REVIEW OF RISK BASED EVALUATION OF
INTEGRATED SAFETY ASSESSMENT (ISAP) ISSUES
FOR MILLSTONE UNIT 1 - PHASE 2

August 15, 1985

U.S. Nuclear Regulatory Commission
Washington, D.C. 20555

Contract No. NRC-03-82-096

Figure 5.1. Logic Trees to Aid in Selection of Expected Behavior Type.

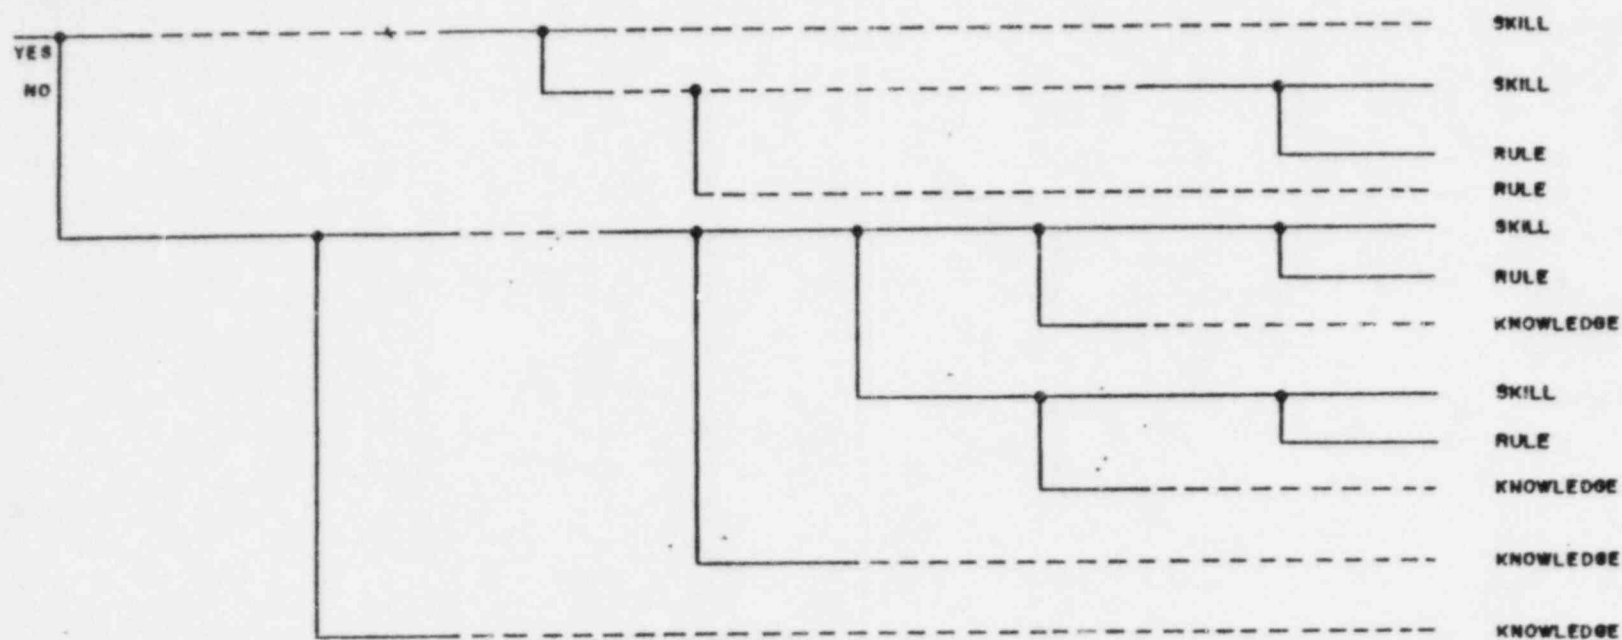
Figure 5.1 is a reproduction of Figure 4.2-3 of the Millstone Unit 1 PSS. This figure shows the logic that was used by each analyst in classification of different human action into one of the above categories. This guideline was used so that the classification done by different analysts is performed in a consistent manner. It should be noted, however, that a certain amount of "analyst creativity" is required in using this logic tree. For example, a nonroutine operation which is covered by a well written, understandable procedure might still be classified as knowledge-based if the amount of time available is short. In this case, the operator

may not have time to access the procedure, which would make the operation equivalent to one which lacked a procedure.

Figure 6.1. Comparison Between Dominant ISAP and IREP Contributors to the Core Melt Frequency.

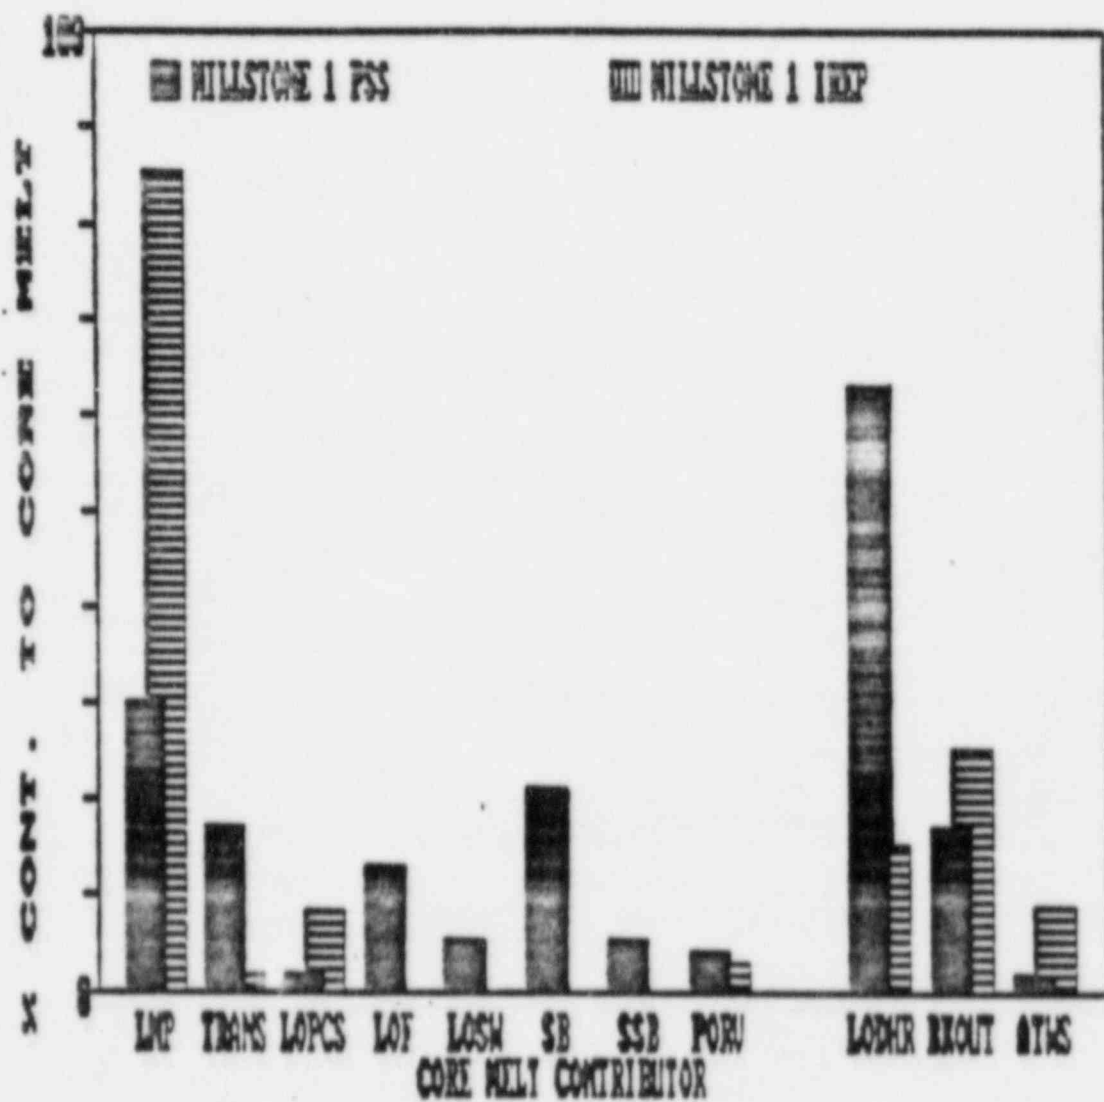
Reasons for this decrease:

- a. Reductions in failure rate data of the diesel generator, gas turbine generator, and switchgear breakers.
- b. Modification to LNP logic to eliminate single relay failures.
- c. Modification to IC makeup to eliminate admission valve AC dependency.
- d. Change to symptom-oriented procedures eliminated confusing procedure for initiating manual depressurization when required, reducing human error probability.

The only mitigative factor that limited the amount of decrease in the ISAP core melt contribution was an increase in the failure probability of the alternate SDC system due to changes in its success criteria.

In addition to the above classes of initiators, three groups of events are also compared in Figure 6.1. The first one is the group of events leading to core melt that include Loss of Decay Heat Removal (LODHR) function. In this case, the ISAP dominant sequence frequencies have increased substantially due to the increased failure probability of the alternate SDC system as a result of the change in its success criteria.

1. Reductions in failure rate data of diesel and gas turbine generators and switchgear breakers.
2. Modifications to LNP logic to eliminate single relay failures.
3. Modifications to IC makeup to eliminate admission valve AC dependency.

The last group of events shown in Figure 6.1 is the Anticipated Transients Without Scram (ATWS) sequences. The overall ISAP core melt contribution in this case has decreased due to credit allowed for operator action to initiate the standby liquid control system (43 gpm) and take other actions to mitigate the event. This decrease was limited by a significant increase in the RPS failure probability, based on a simple statistical analysis. This event was assumed to lead to core melt in the IREP study. This assumption is one of the topics that will be discussed in more detail in the next section.

Figure 6.2. Simplified Fault Tree for the Failure of Alternate SDC System

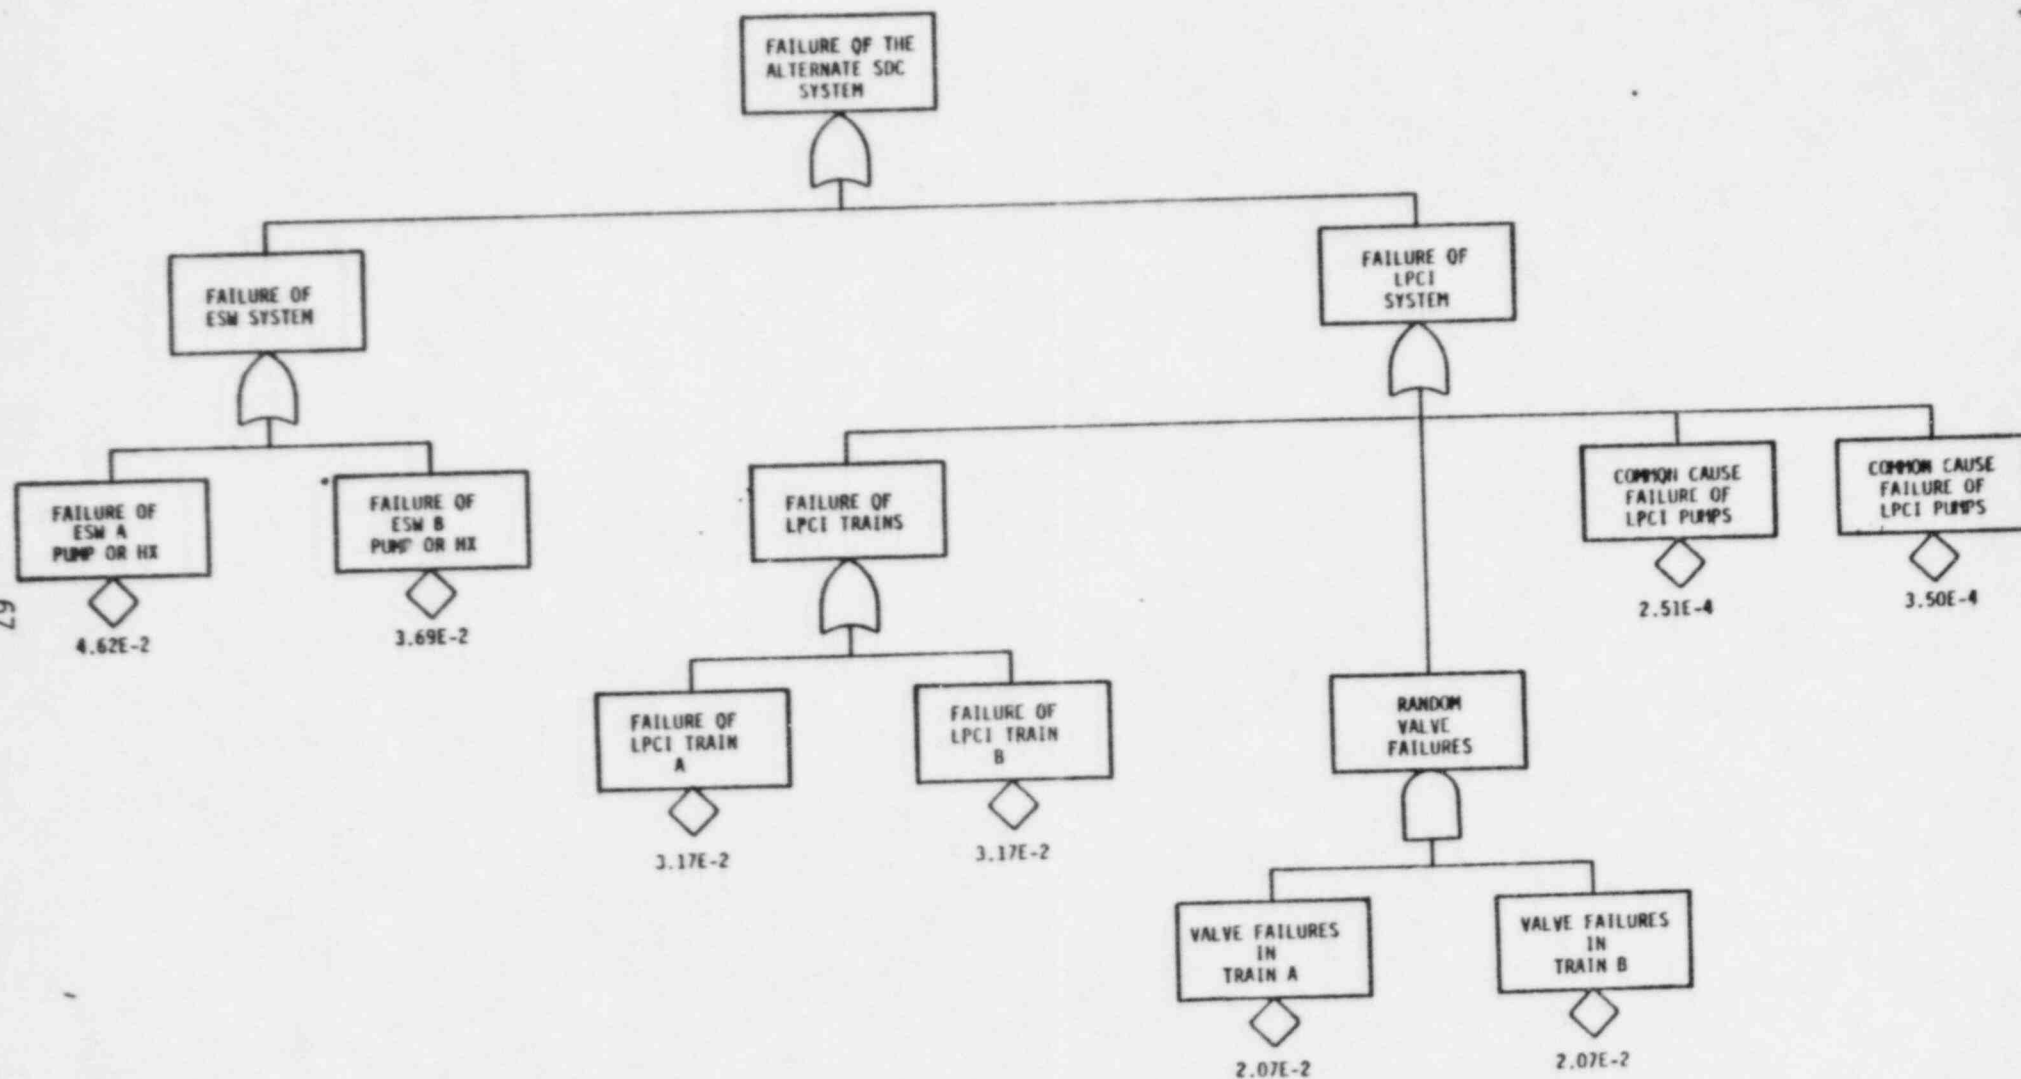
The first area is the reliability of the alternate SDC system. Referring to Figure 6.1, it can be seen that sequences involving loss of the decay heat removal system contribute to about 65% of the total core melt frequency. This contribution is substantially higher in the ISAP study compared with the IREP study. As has been mentioned previously, this increase is primarily due to the higher failure probability associated with the alternate SDC system. The increase in the failure probability of the alternate SDC system is due to the change in its success criteria.

In the IREP study, the success criteria for this system consisted of successful operation of one LPCI pump and the associated containment cooling heat exchanger with one Emergency Service Water (ESW) pump removing heat from the heat exchanger. Based on some new thermal hydraulic calculations, the success criteria for this system were changed in the ISAP study by requiring two LPCI containment cooling heat exchangers with one LPCI pump per heat exchanger and all four emergency service water pumps to remove the heat from the containment cooling heat exchangers. This change has dramatically increased the failure probability of this system.

To assess some alternatives in reducing the failure probability of this system, the detailed fault tree for this system, shown in Figure 3.2.24-2 of the Millstone Unit 1 PSS, was simplified and is shown in Figure 6.2. Based on the current configuration, the failure probability of this system with no support system failure is 0.148. Three scenarios for improvement in the reliability of this system were examined. In the first case, it was assumed that the LPCI/containment cooling loops are made redundant. In the second case, it was assumed that the emergency service water loops are made redundant. In the third case, it was assumed that both of the above improvements were incorporated. Table 6.2 shows the results of these evaluations. Incorporation of redundancy in the LPCI alone resulted in the reduction of the failure probability of the alternate SDC by a factor of about 1.7. The effect of making the ESW loop redundant is a reduction in the failure probability of the alternate SDC system by a factor of about 2.2. If both of these changes are incorporated, the failure probability of this system can
